**AGENDA  
CITY OF CEDAR FALLS, IOWA  
PLANNING AND ZONING COMMISSION MEETING  
WEDNESDAY, DECEMBER 12, 2018  
5:30 PM AT CEDAR FALLS CITY HALL**

**TO:** Planning & Zoning Commission  
**FROM:** David Sturch, Planner III  
**DATE:** December 6, 2018  
**SUBJECT:** College Hill Neighborhood Site Plan Review – 2119 College Street

**REQUEST:** Request to approve a College Hill Neighborhood District Site Plan Review for a new multi-use building at 2119 College Street.

College Hill Neighborhood Overlay  
District Site Plan Review

LAYOUT PLAN

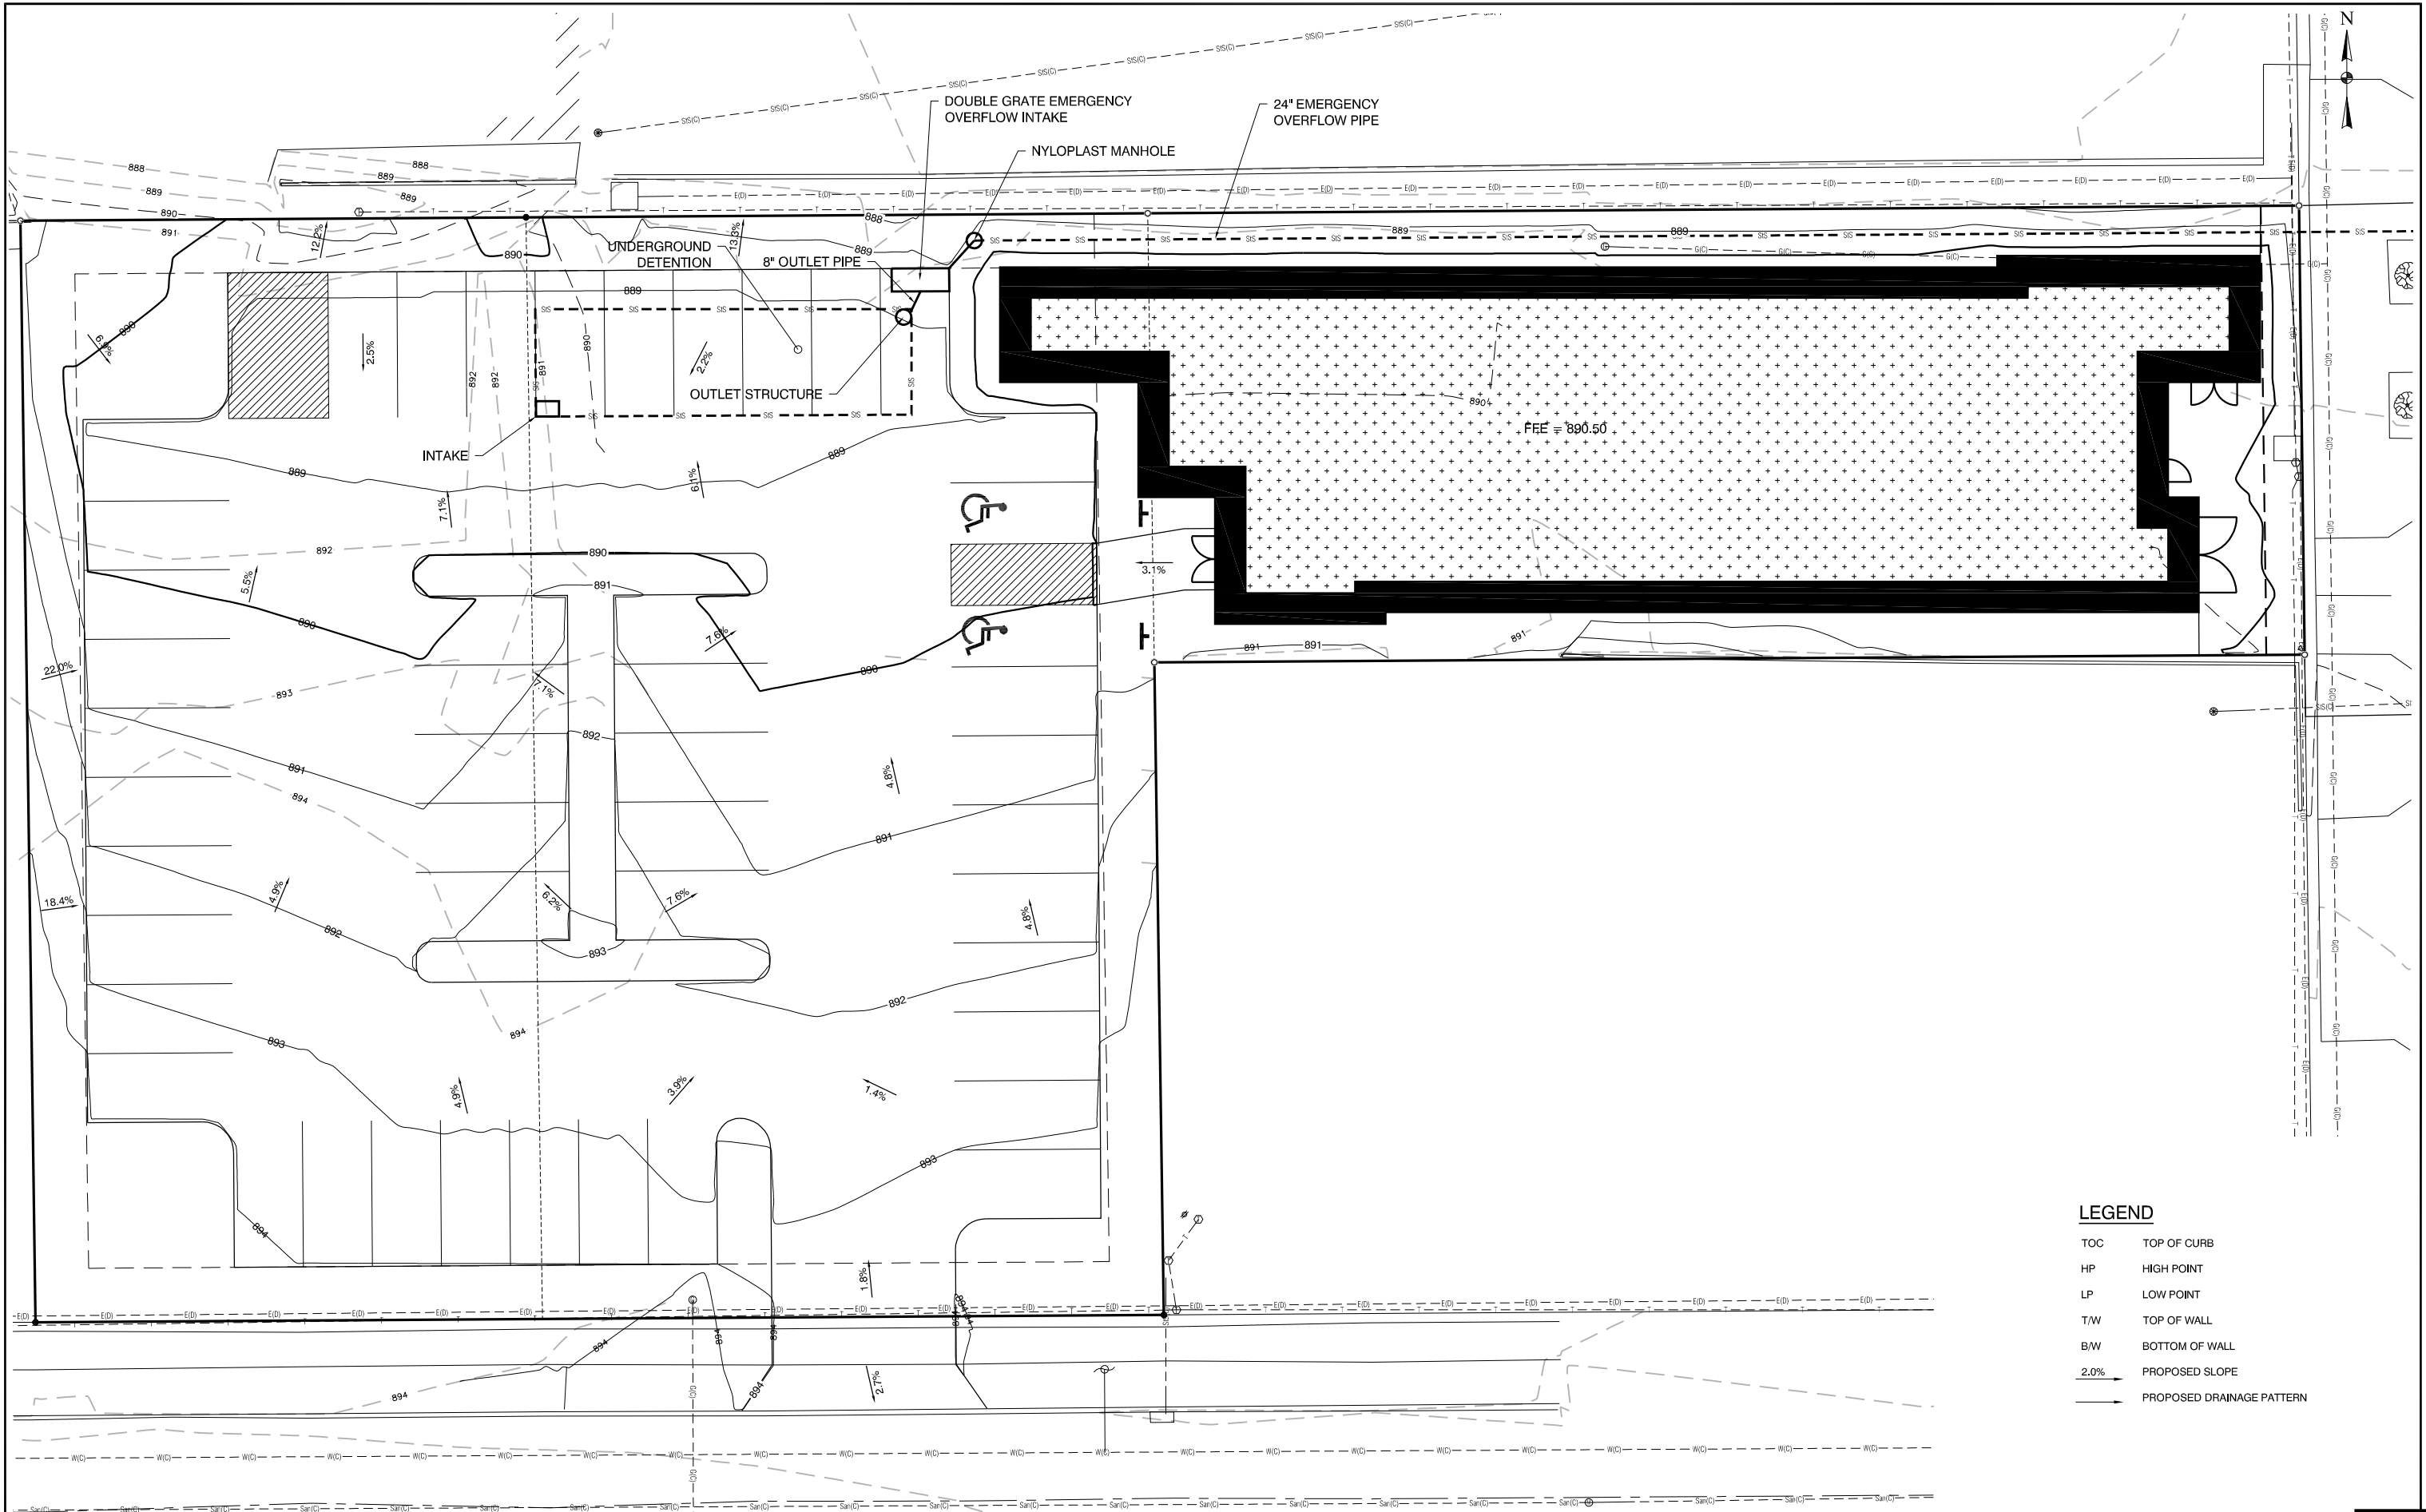
- 2) Building and Parking Lot Setbacks: The property is zoned C-3 Commercial District. Principal commercial uses within this district are not required to be setback from the property lines. The site plan shows the building having a varied front setback from College Street, with the closest façade being 5 feet from the front property line. A 6-foot building setback is proposed from the north lot line and a 5-foot building setback from the south lot line. The parking lot situated along W. 22<sup>nd</sup> Street provides a 7-foot setback along all property lines. The minimum parking lot setback in the C-3 commercial district is 5 feet. **Building and parking lot setbacks are satisfied.**

- 8) Trash Dumpster Site: The site plan shows a dumpster enclosure contained within the parking area at the northwest corner of the lot. The 8'-0" tall trash enclosure is constructed with a brick wall to match the building with metal doors. The landscaping plan shows trees,

## GROUND LEVEL PARKING PLAN

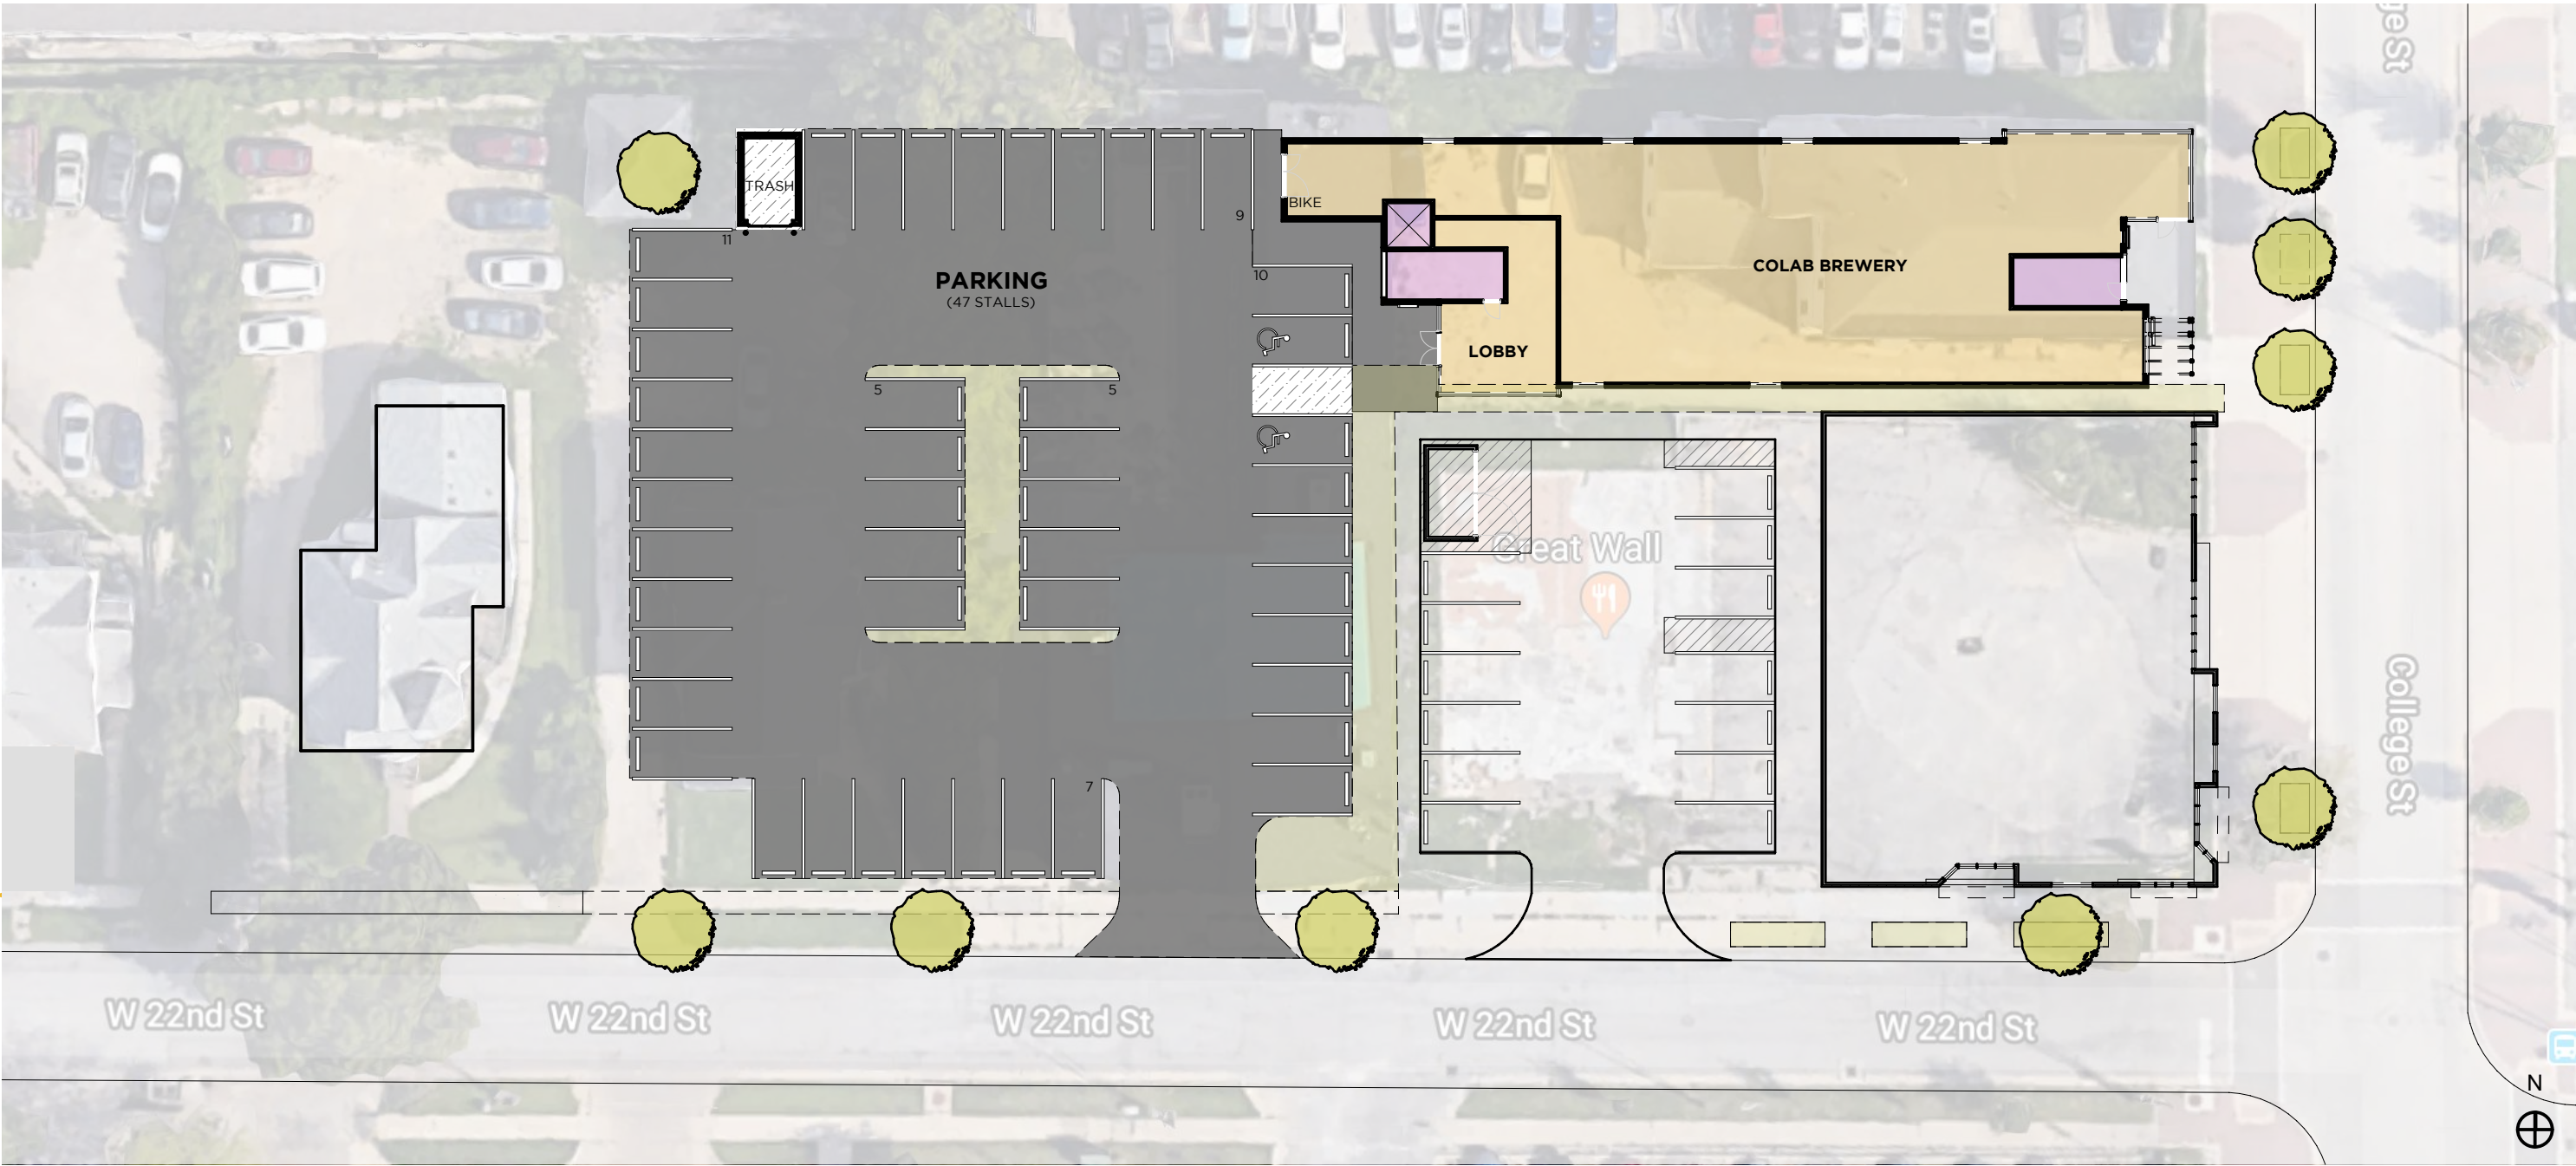
The background on this issue is well known. This revised site plan for 2119 College Street is quite different than previous plans submitted for this lot. However, the plan still suffers from the fatal flaws contained in all prior plans—violation of the Code of Cedar Falls regarding parking. While the building size has decreased, the applicant has also reduced parking. Prior site plans provided 48% of parking required by Code. The current plan provides 62% of required parking.

Under Ordinance §§ 29-177(a)(12B) & 29-160(e)(1)(c) this building requires: 46 spaces for the 23 studio units; 8 spaces for the 4 two-bedroom units; 16 spaces for the 4 four-bedroom units; and at least 5 visitor spaces. This totals 75 required spots, yet only 47 are provided. Prior site plans included one level of underground parking, which could provide some of these missing spots, yet the applicants have eliminated all underground parking from the current plan.

### CEDAR FALLS BUILDING HEIGHTS

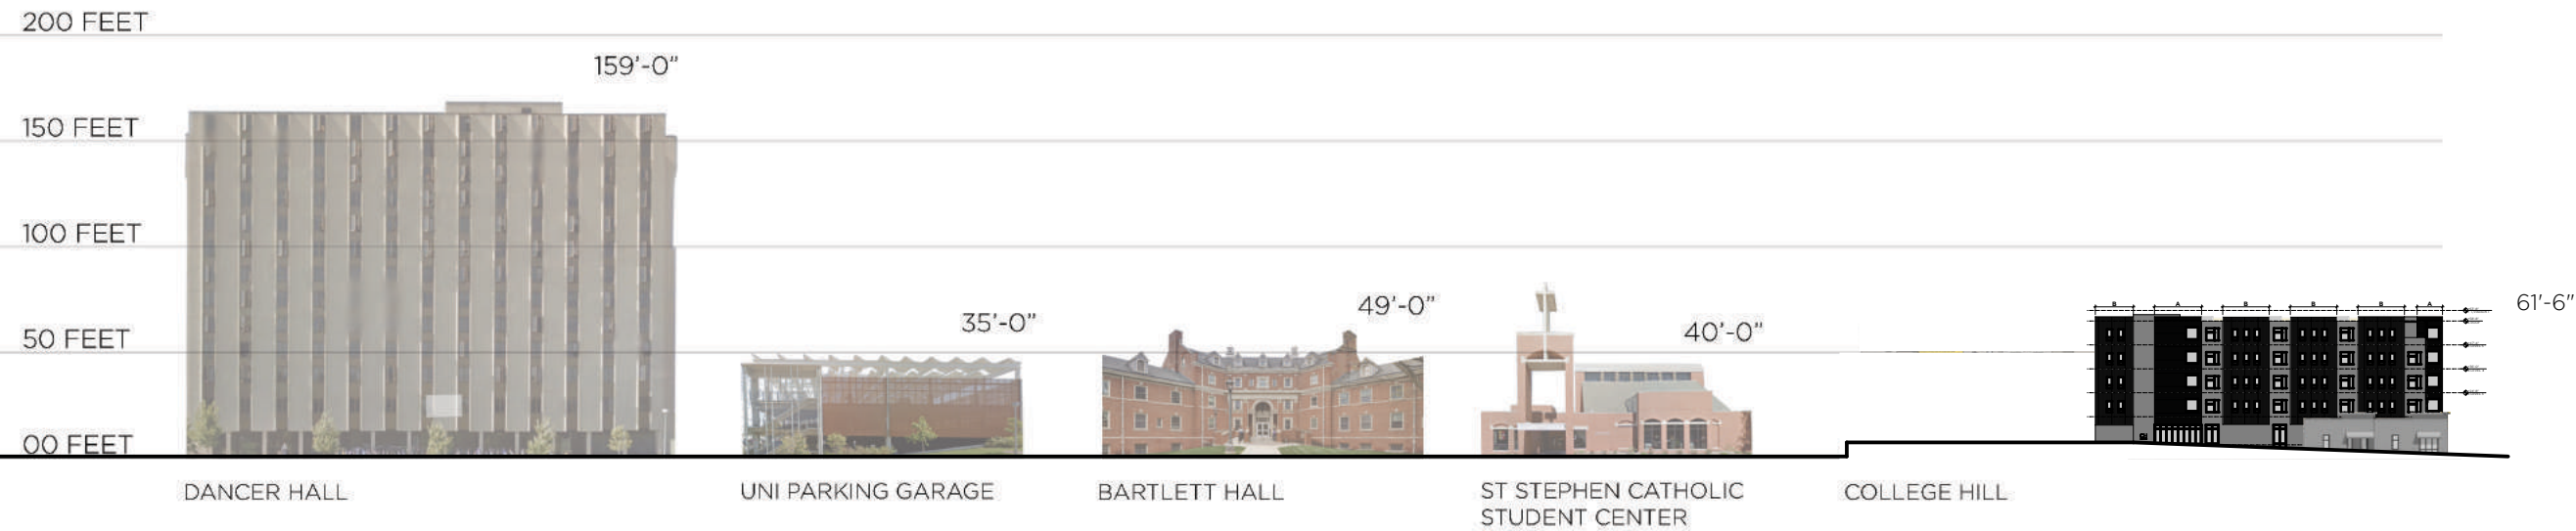
The applicant has provided a diagram which shows several other buildings within a 2-3 block area that are taller than the proposed building (see attached diagram for building locations). In the diagram, it shows the proposed building with a height of approximately 62 feet. Other buildings in the area and their heights include the St. Stephen Catholic Student Center on W. 23<sup>rd</sup> Street at 40 feet in height, Bartlett Hall on the UNI campus on W. 23<sup>rd</sup> Street at 49 feet in height, the UNI parking garage on W. 23<sup>rd</sup> Street at 35 feet in height, and Dancer Hall on Campus Street on the UNI campus at 159 feet in height. Also, the applicant has provided a side elevation diagram which shows the street section of buildings located on College Street and their height comparison to the proposed building. Based on the diagrams presented below, staff feels that the building scale and height will not be out of character for the area, as there are other structures within the neighborhood that are comparable in scale and height to the proposed building.

## ELEVATIONS

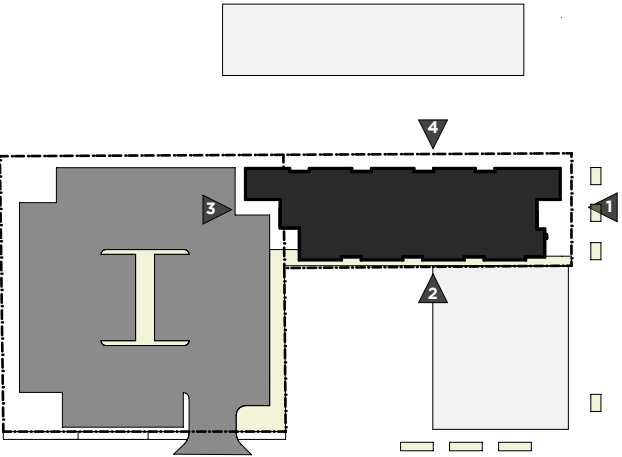
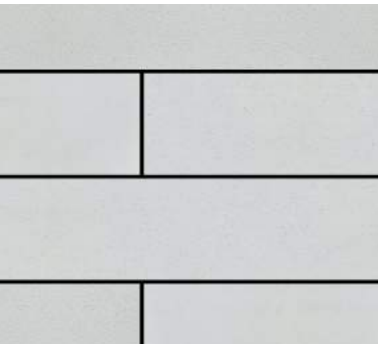
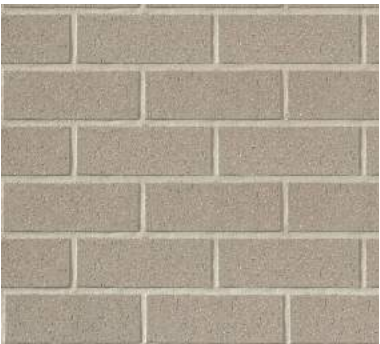
Most of the buildings in this immediate neighborhood are constructed with brick materials. The proposed building will have a more modern look, as it will be constructed with a mix of metal paneling (with a contrasting color and design), brick and glass openings. The colors include charcoal/black for the entry masses at the front and rear of the building with off-white as the metal panel along the larger north and south portions. The brick is planned to be a neutral tan/gray with brick detailing similar to the image shown at key locations. Each of the four sides of the building will have a slightly different design in relation to the amount and type of materials used. Please see the table below which breaks down the use of materials by building side.

The building has a width of 45 feet as viewed from College Street, but is broken into three modules, distinguished by changes in building material, wall plane, colors, and textures. The sides and rear of the building are also broken into modules with similar changes in material, color, and changes in the wall plane that helps to break up the mass of the building from all vantage points.
